1994 Chevrolet Caprice V8-350 5.7L

Transmission Oil Filter Assembly

Bulletin No.: 377142A

NEW TRANSMISSION OIL FILTER ASSEMBLY

Figure 1

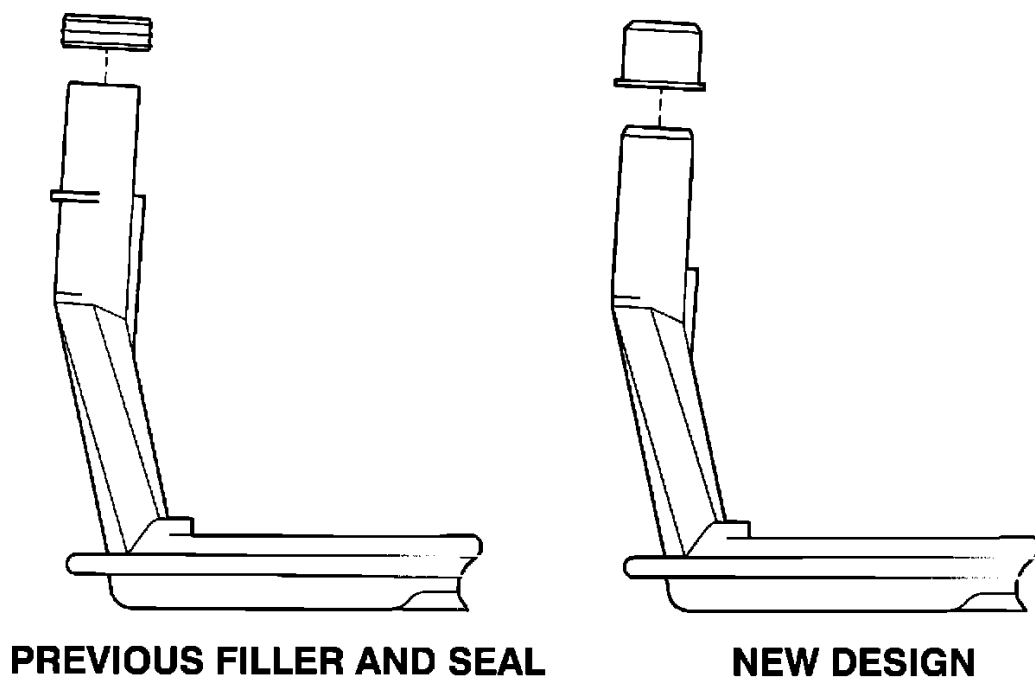
DATE OF PRODUCTION CHANGE:
(Figure 1 and 2)

On August 10, 1993 (Julian Date 222), HYDRA-MATIC 4L60-E transmissions were built with a new filter seal (ill. 71) and transmission oil filter assembly (ill. 72).

The previous transmission oil filter assembly and filter seal had an assembly method of installing the seal on the filter neck and then installing the filter in the transmission.

When using the new filter seal and transmission oil filter assembly, the filter seal must be installed in the transmission first and then install the transmission oil filter assembly into the transmission.

The new filter seal and transmission oil filter assembly can be used on all HYDRA-MATIC 4L60-E transmissions 1993-1994. The new filter seal and transmission oil filter assembly cannot be used on any HYDRA-MATIC 4L60 transmission.

The new filter seal cannot be used with the old transmission oil filter assembly and the new transmission oil filter assembly cannot be used with the old filter seal.
